**ALLEGHENY COUNTY SANITARY AUTHORITY**

**CONTRACT NO. 1735 G, E, H, P**

**ALCOSAN PARKING GARAGE**

**ADDENDUM NO. 2**

**2 EAST BUILDING ELEVATION**  
 SCALE: 3/32" = 1'-0"

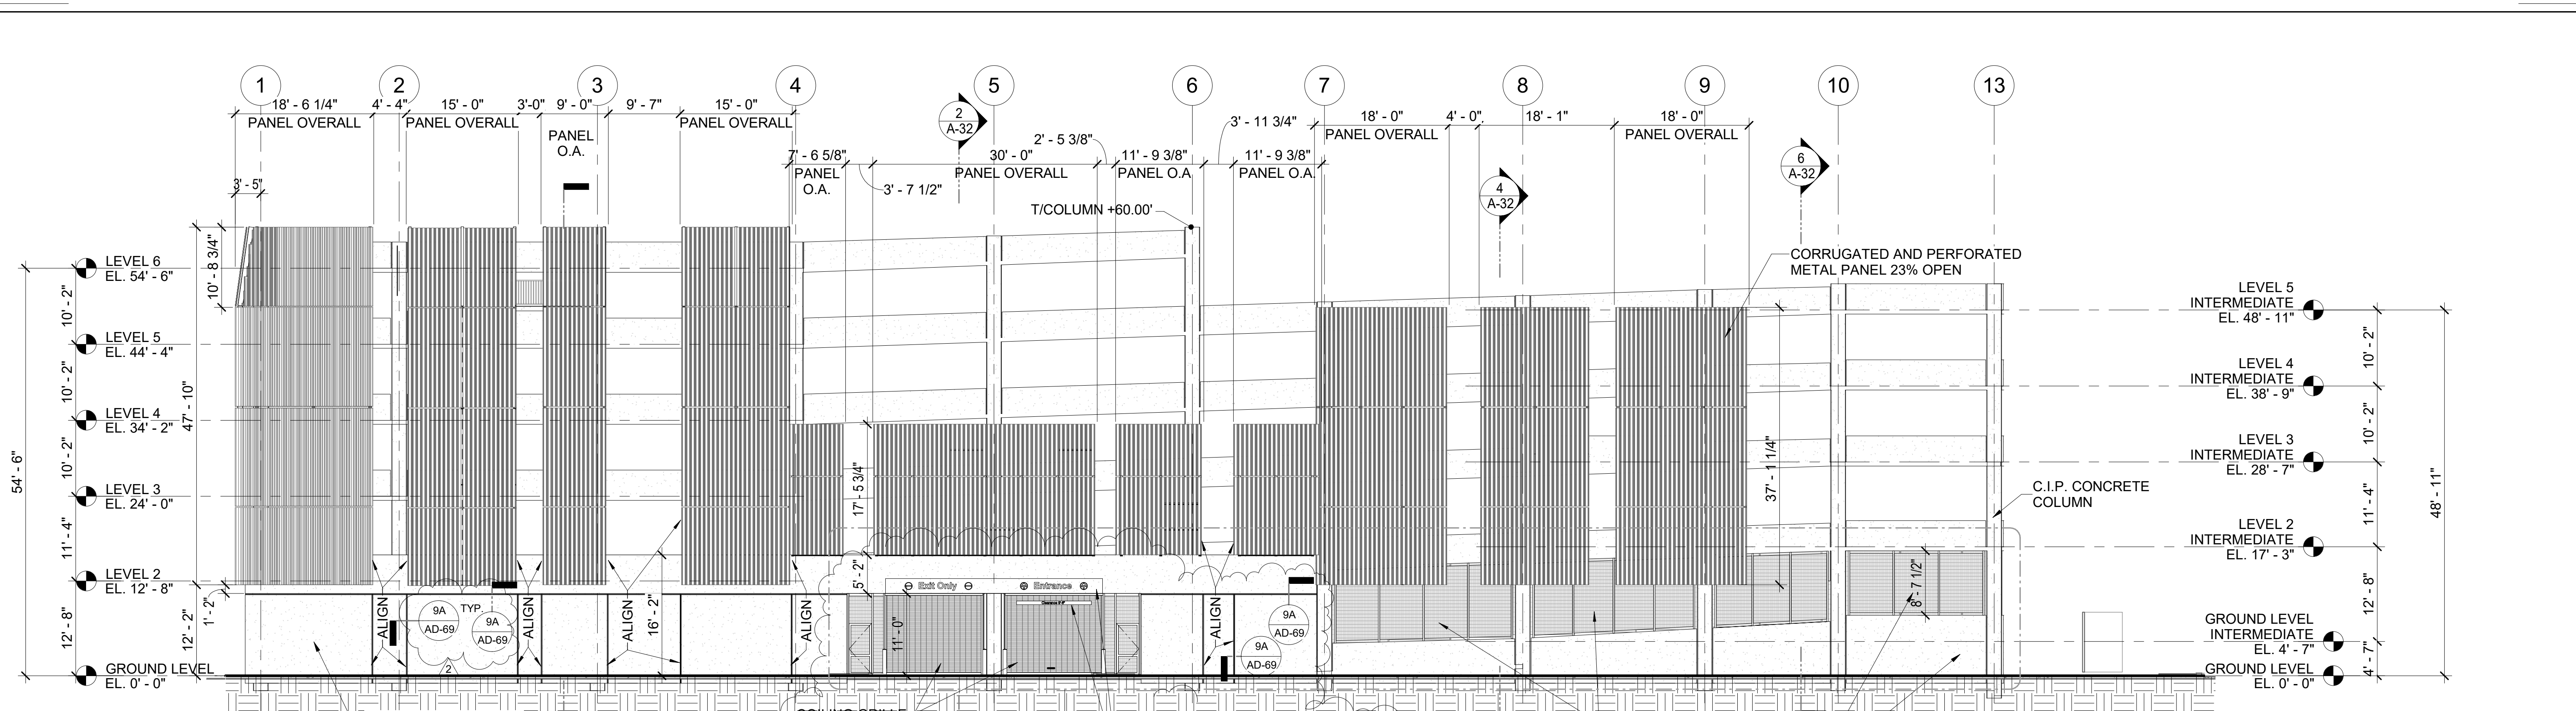
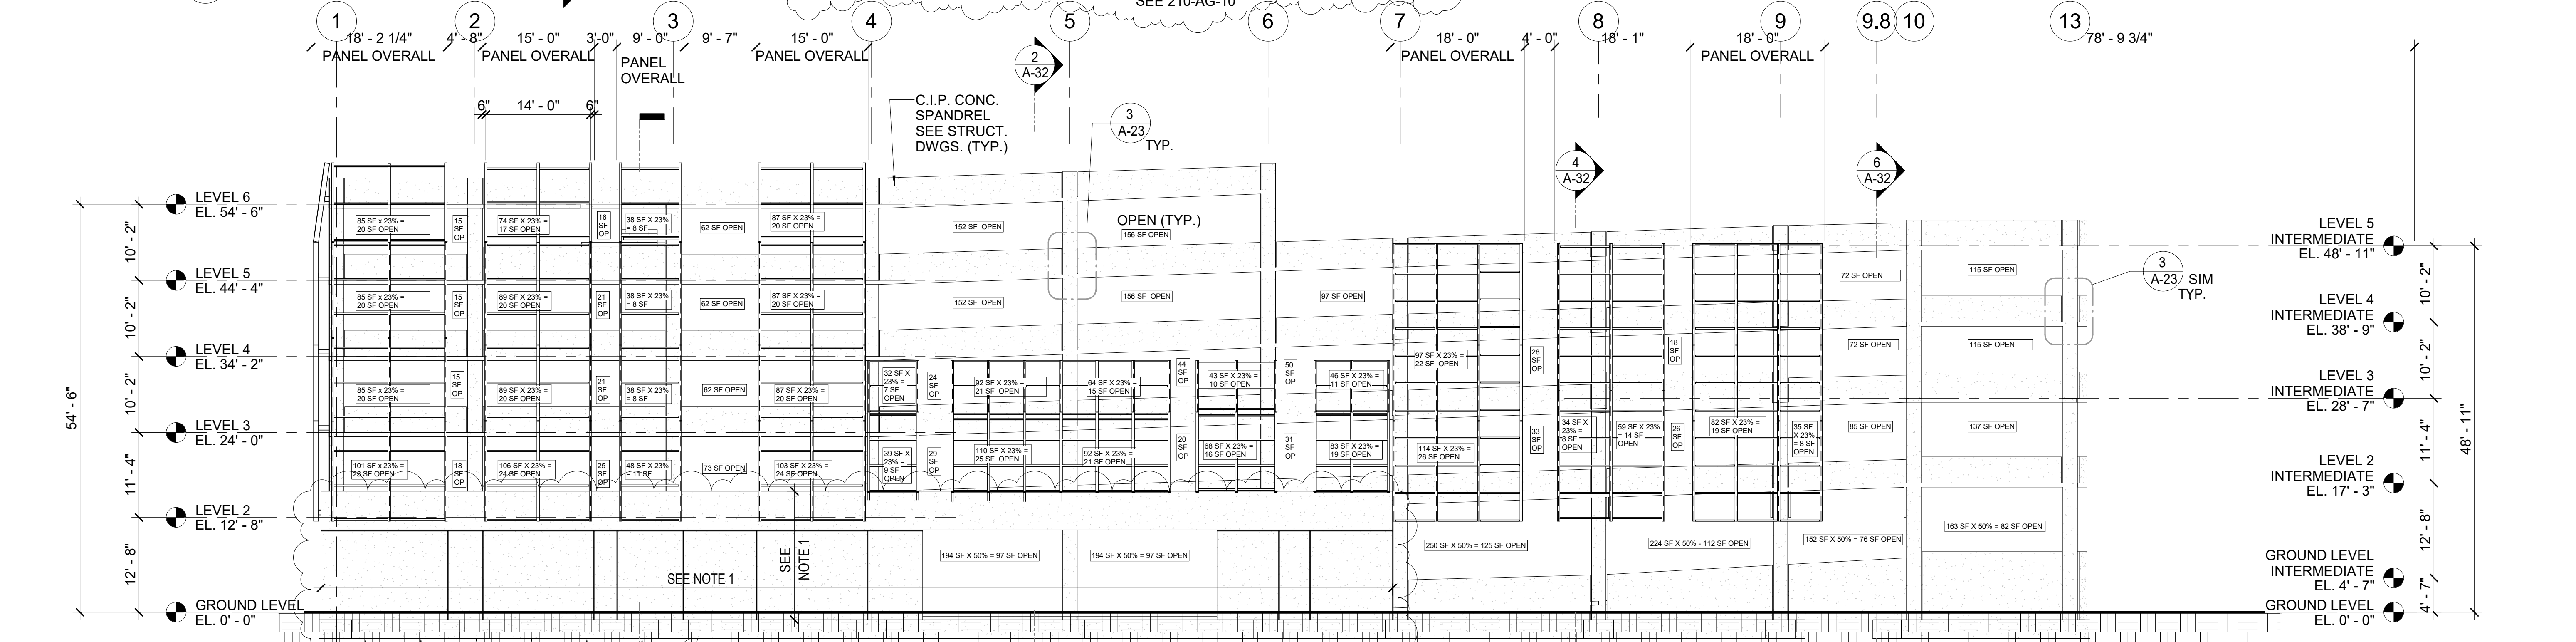
12. Drawing 210-A-20 - East Building Elevations
  - a. REPLACE with the attached drawing 210-A-20.
  - b. In elevation 1, limits of architectural concrete are shown

2 SOUTH BUILDING ELEVATION

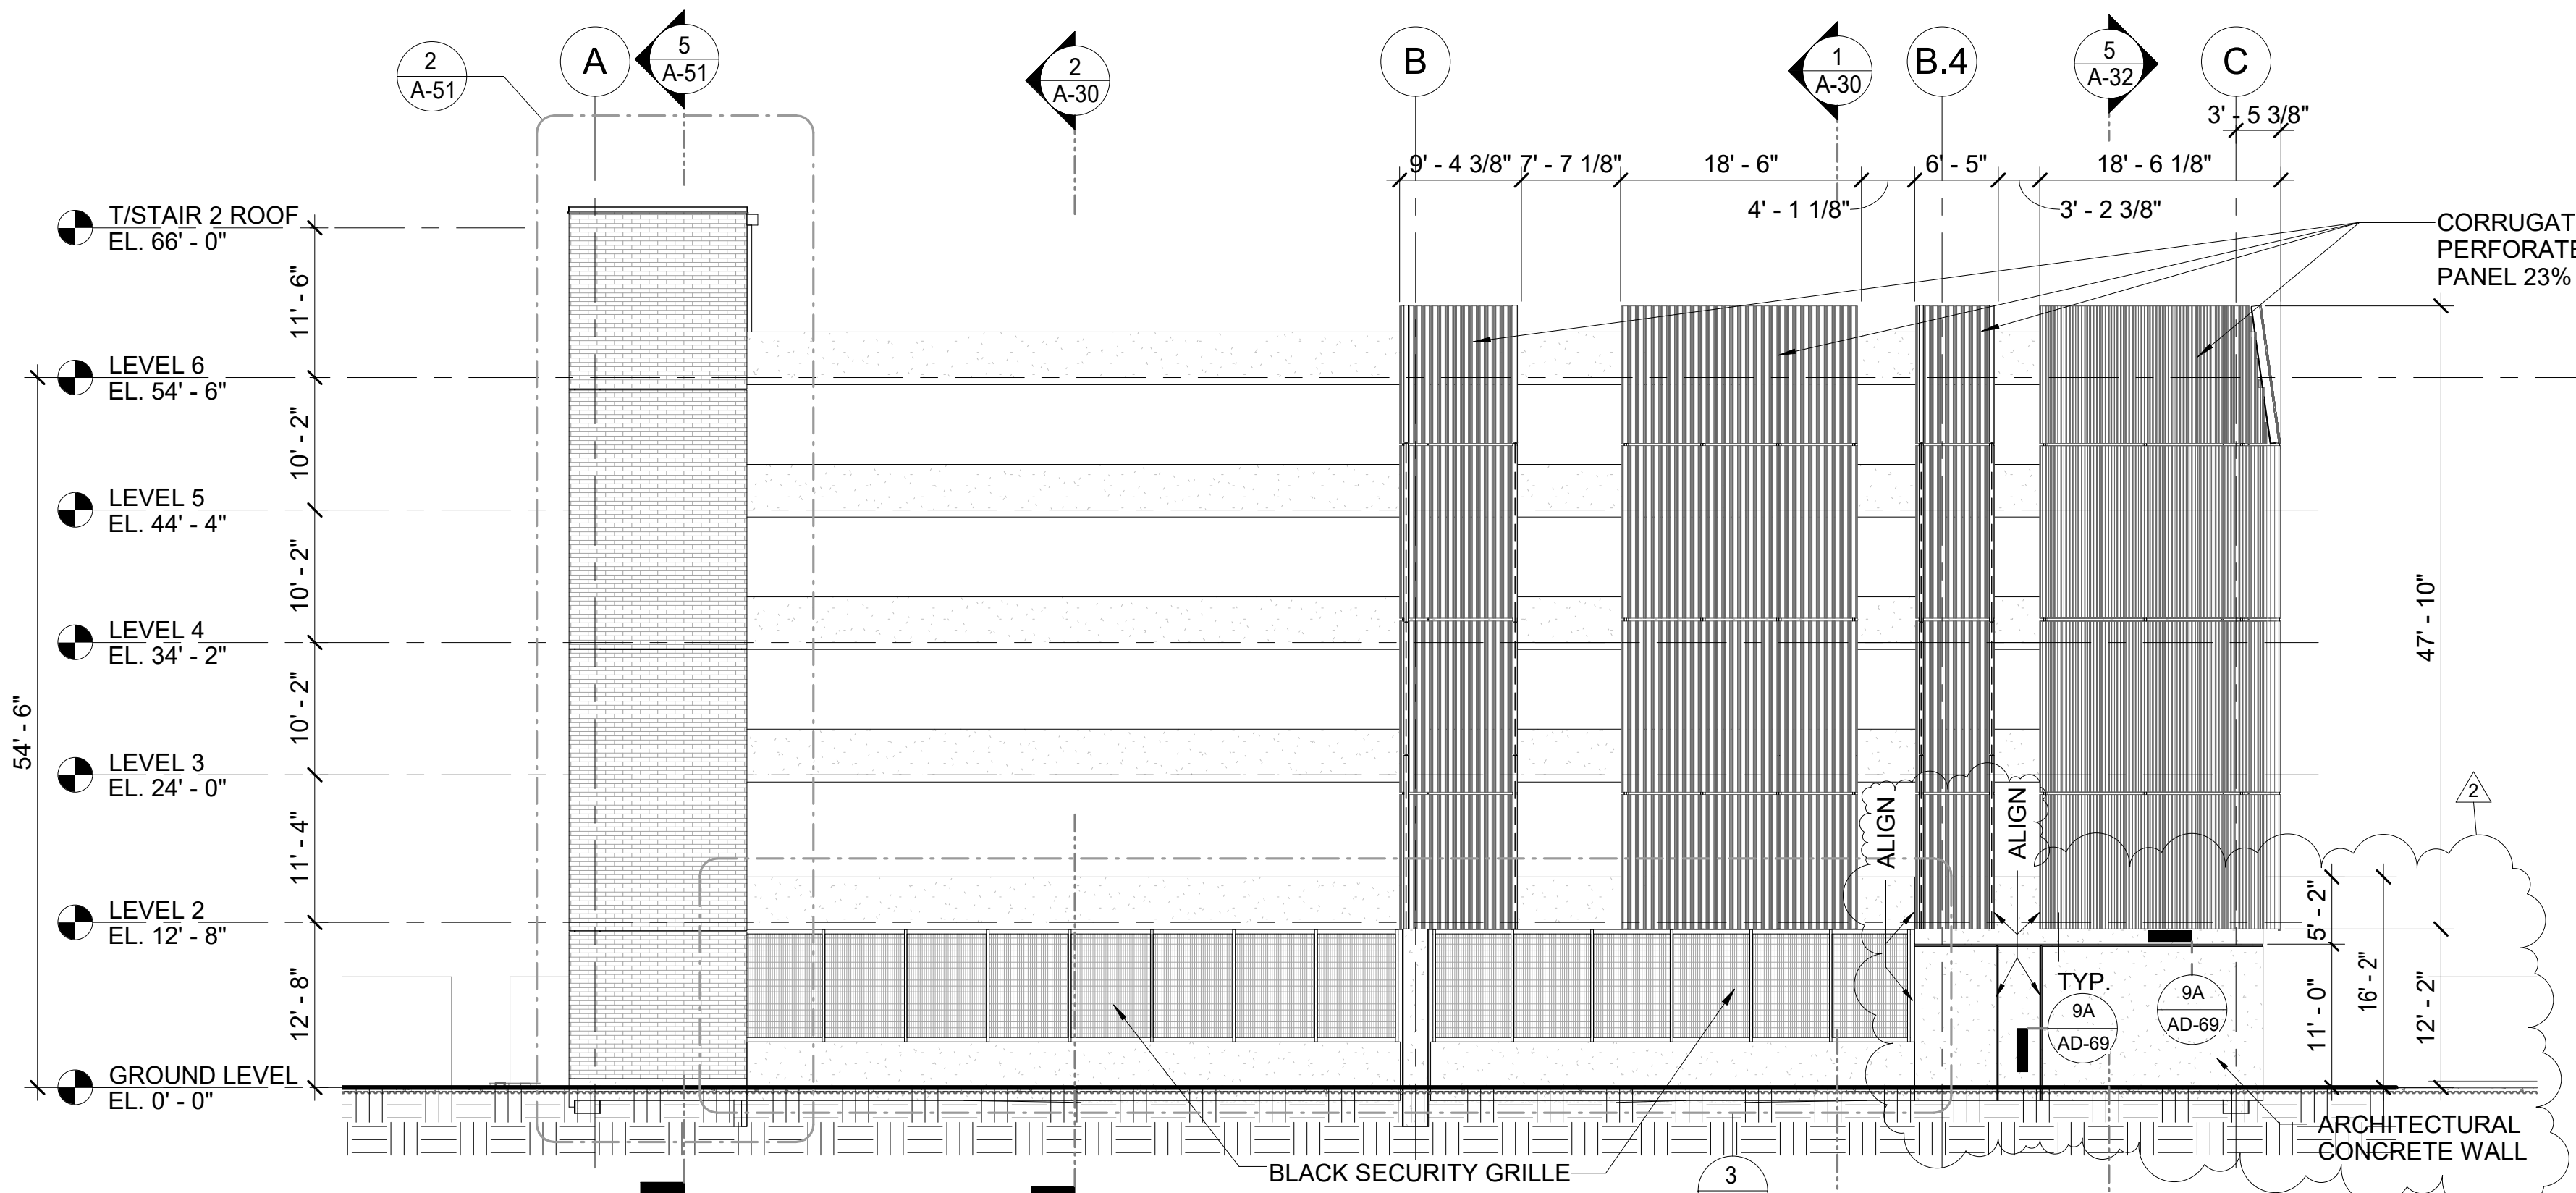
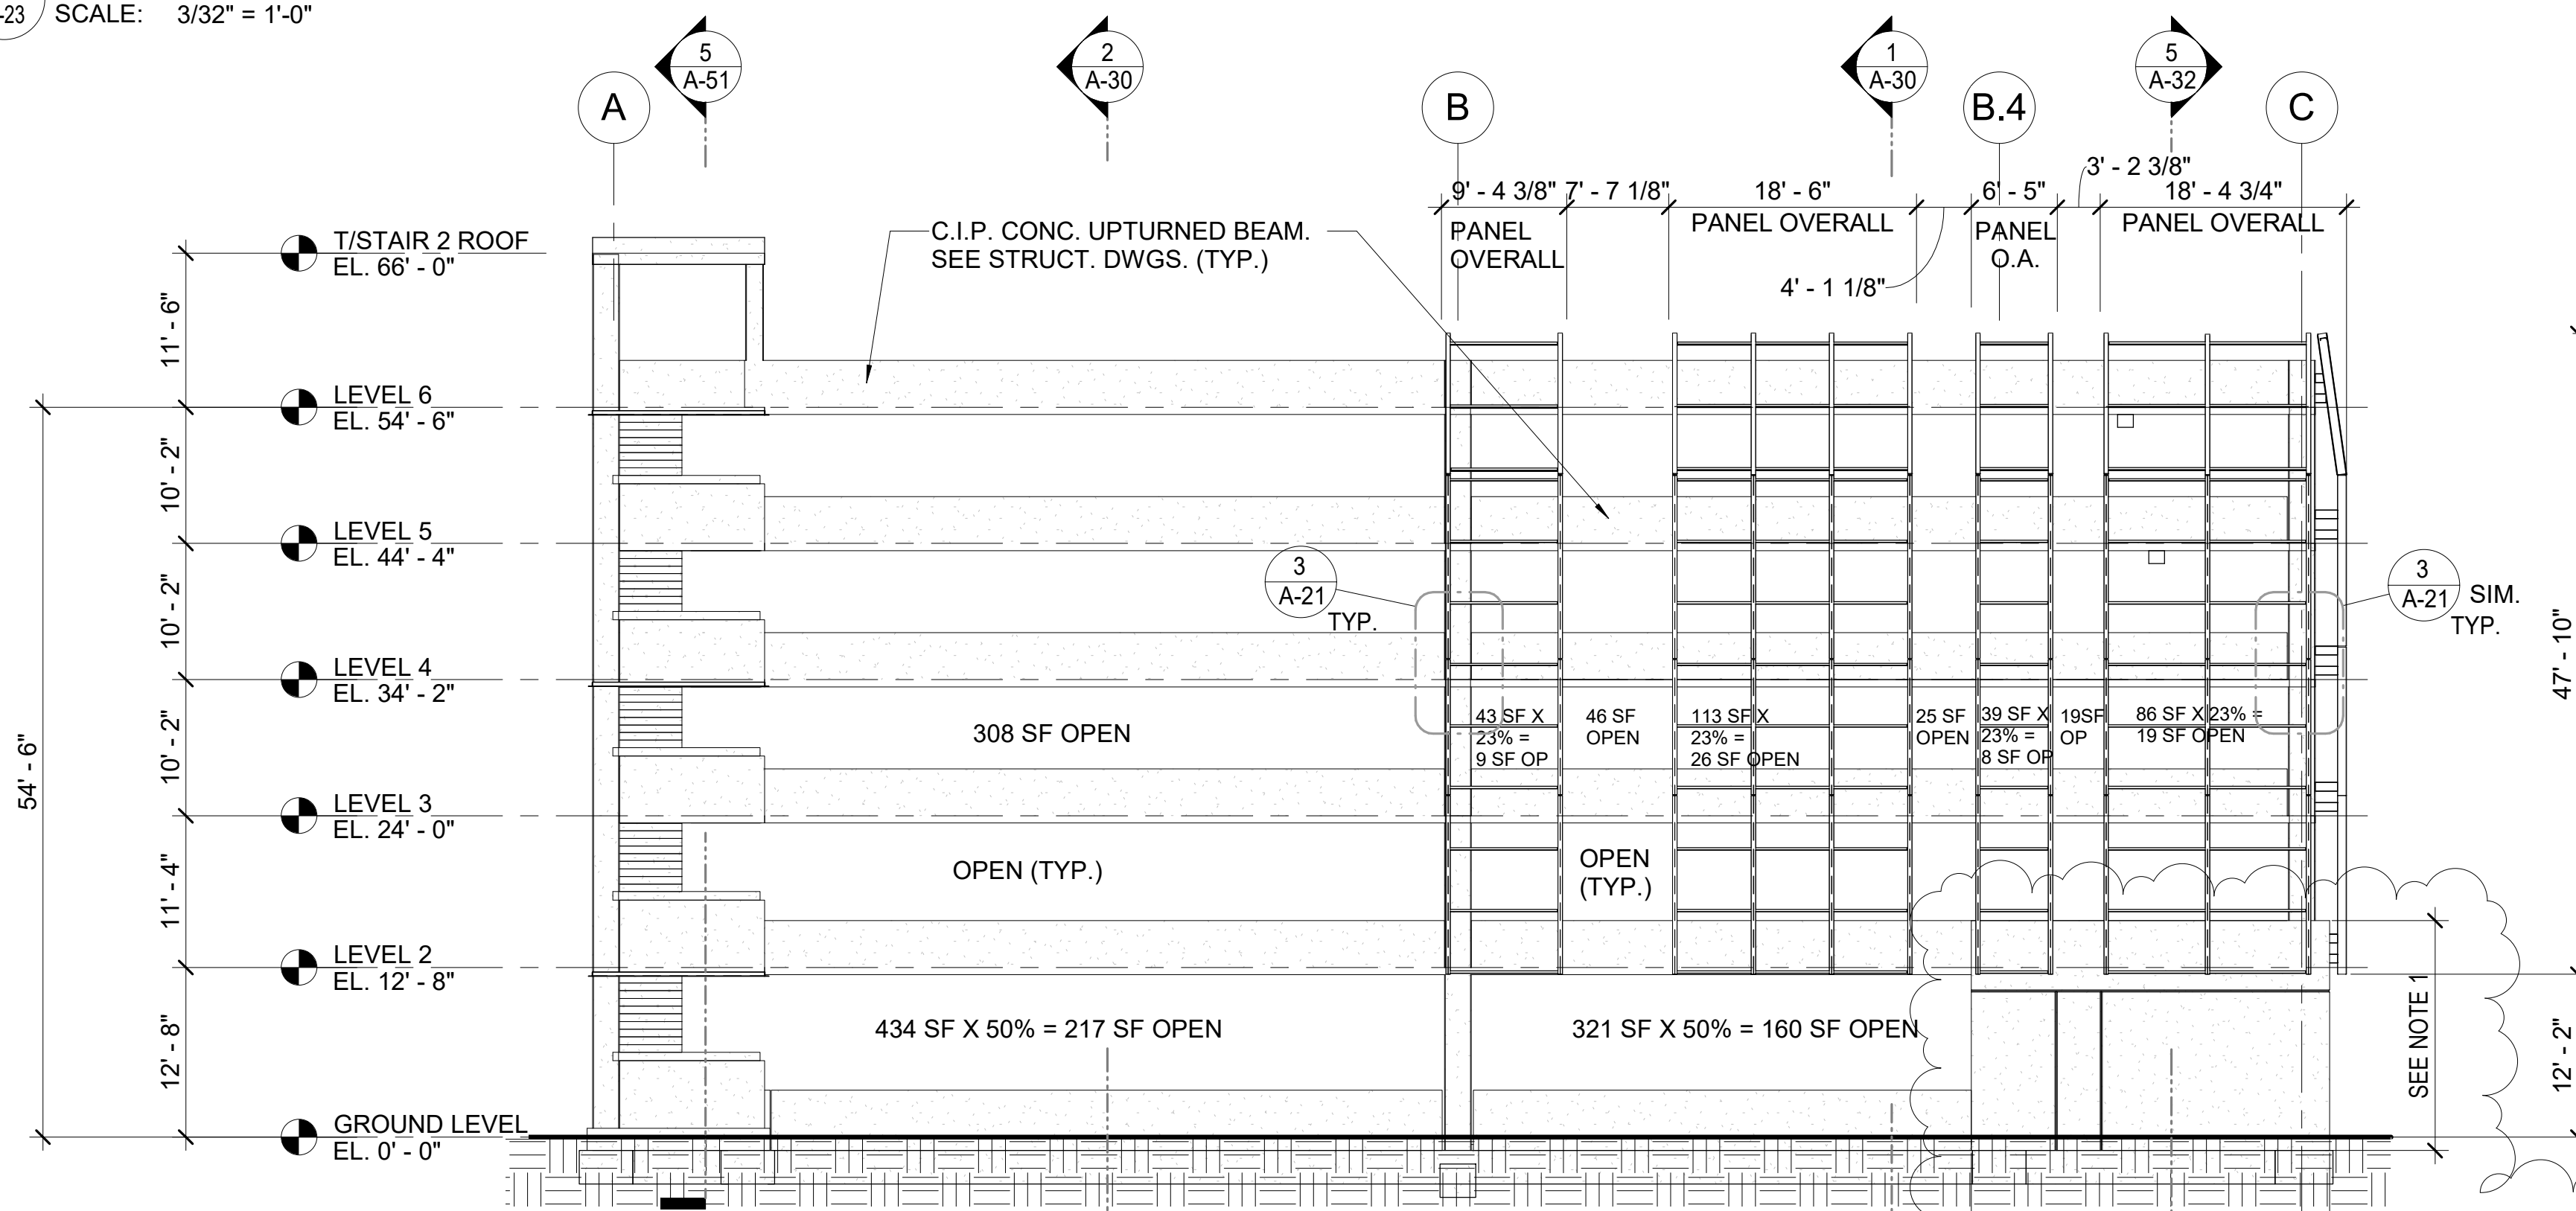
13. Drawing 210-A-23 - South Building Elevations
  - a. REPLACE with the attached drawing 210-A-23.
  - b. In elevation 1, limits of architectural concrete are shown

- c. There is no textured concrete in the garage project.
  - d. In elevation 2, reveals at architectural concrete are revised.
14. Drawing 210-A-30 - Building Sections
